British Gliding Association – Technical Committee**Technical News Sheet 05/06/00****Part 1** **Airworthiness issues (all categories)**

Technical Note
No.348/13
843/14

**Service Letter
109-1**

KRAFTSTOFFFILTER
 109B-6176

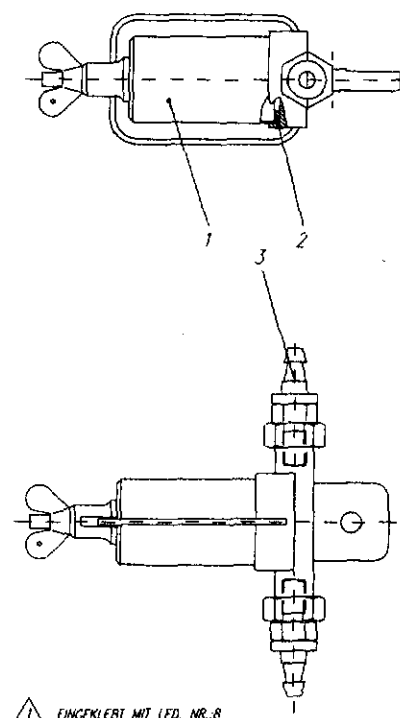
Vorgang: Die im Kraftstoffilter am Brandspant eingebaute Gummidichtung ist in Kürze nicht mehr vorrätig. Aus diesem Grund wird zukünftig eine neue Dichtung 109B-6176.02 eingebaut. Diese Dichtung ist für alle Kraftstoffarten verwendbar. Eine Dichtung für den erstmaligen, kostenlosen Austausch liegt diesem Service Letter bei.

Background: *The rubber seal, installed in the fuel filter at the firewall, is no more available soon.*
Information: *Therefore in the future a new seal P/N 109B-6176.02 will be installed. This seal is usable for all types of fuel. A seal for the first, free replacement is enclosed to this Service Letter.*

Maßnahmen: Die Dichtung ist wie folgt auszutauschen:
- Sicherungsdraht entfernen
- Flügelmutter lösen und Filtergehäuse abnehmen
- alte Dichtung entfernen und neue Dichtung einsetzen
- Filtergehäuse anbauen und Flügelmutter anziehen
- Flügelmutter mit Sicherungsdraht sichern

Action: *Replace the seal as follows:*
- *remove the securing wire*
- *loose wing nut and remove the filter housing*
- *remove old seal and insert new seal*
- *install filter housing and tighten wing nut*
- *secure wing nut using securing wire*

DUO DISCUS CANOPY LOCKING MECHANISM

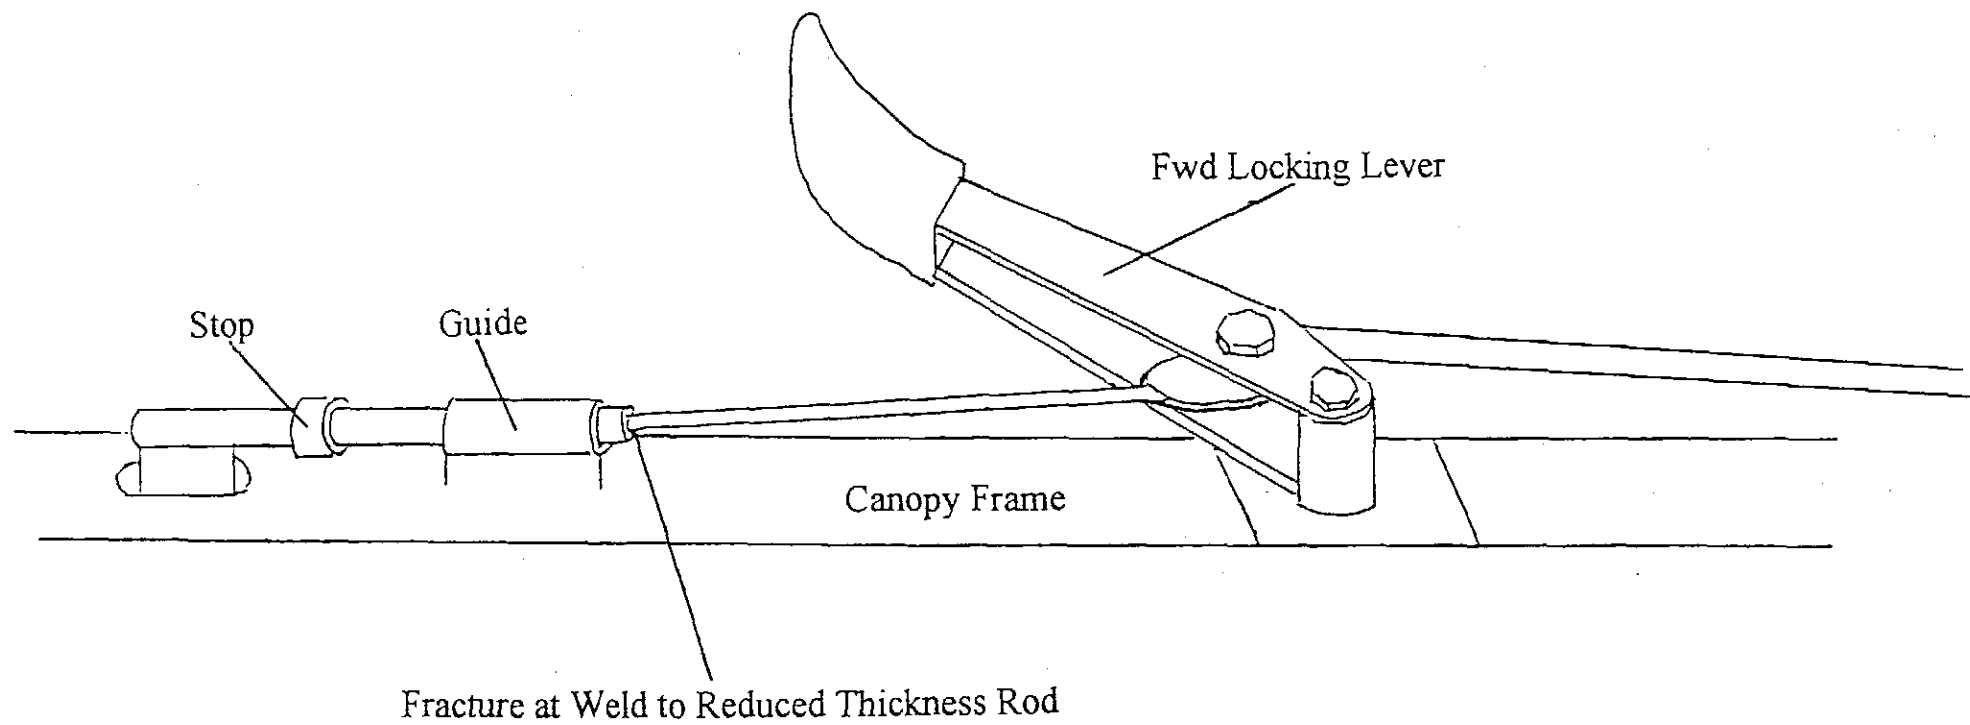
- 1.12 **DUO DISCUS** Defect reported by RAF GSA
Canopy front locking mechanism failed resulting in inability to open to
open canopy. The operating rod fractured at the welded joint at the
diameter reduction. Drawing enclosed. Inspection is required A.S.A.P.
Note; Later aircraft do not have a reduced diameter operating rod.
